**MOORE PUBLIC SCHOOLS -
SOUTH LAKE ELEMENTARY SCHOOL
2022 CLASSROOM ADDITION**
Moore Public Schools - Moore, Oklahoma
AGP - Moore, Oklahoma

ADDENDUM NO. 2
June 7, 2022

ADDENDUM No. 2

T201

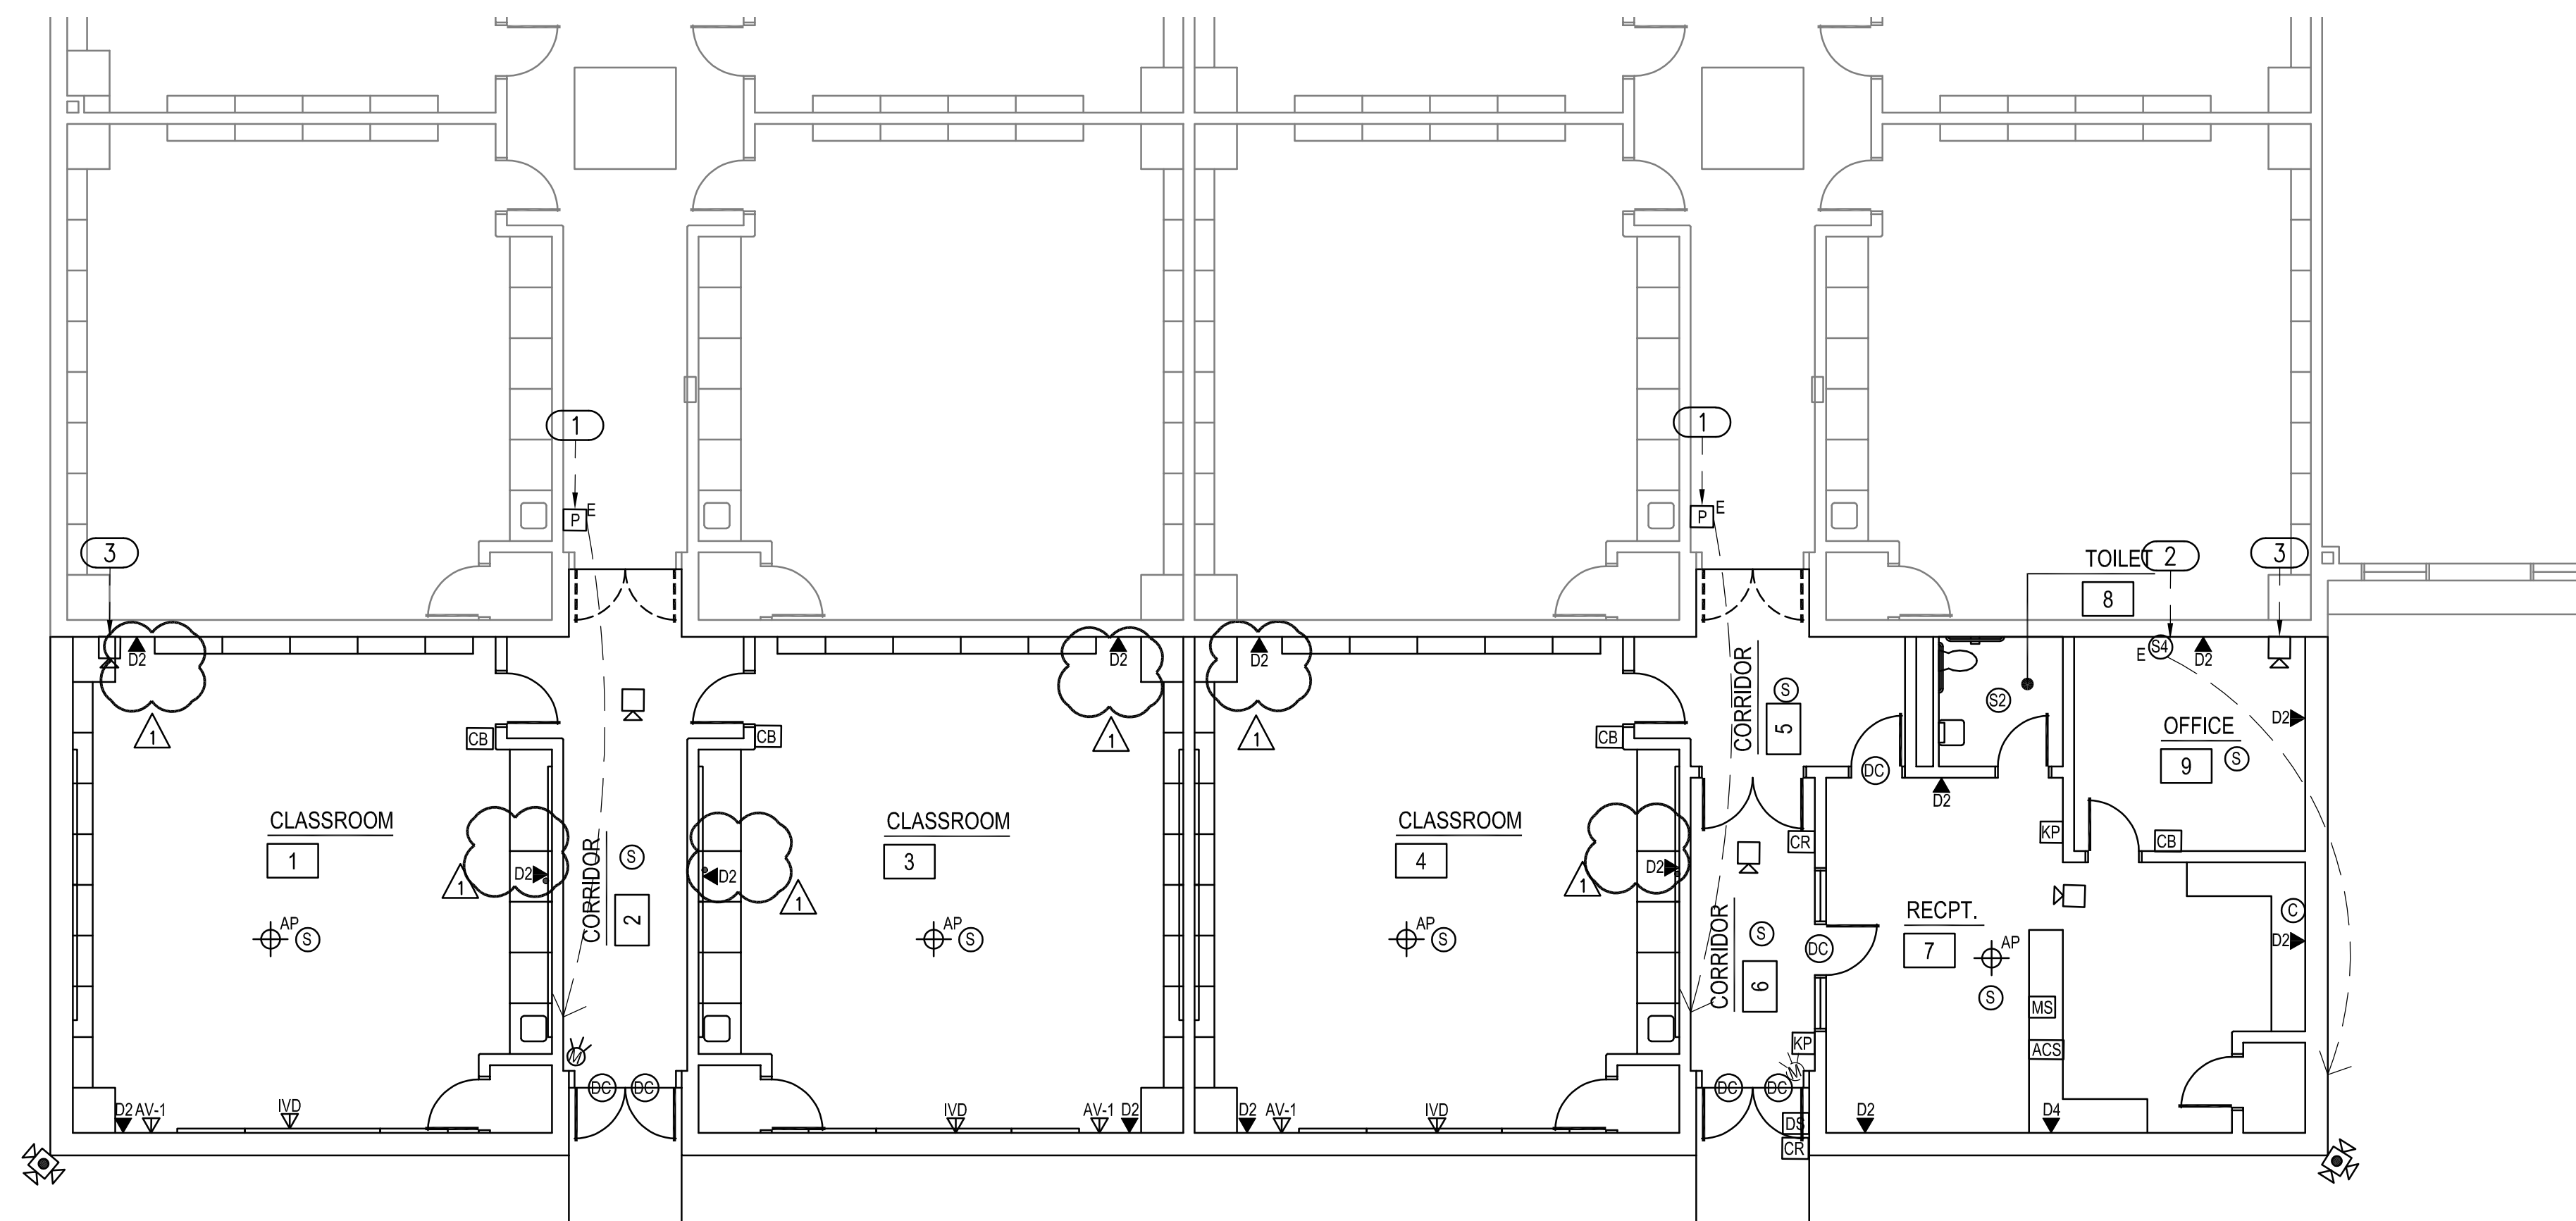
1. T201, Add D2 data outlet to north wall of Classroom 1, 2 and 3.
2. T201, Move D2 outlet on east wall of Classroom 1 and 3 further south so it is accessible.
3. T201, Move D2 outlet on west wall of Classroom 3 further south so it is accessible.
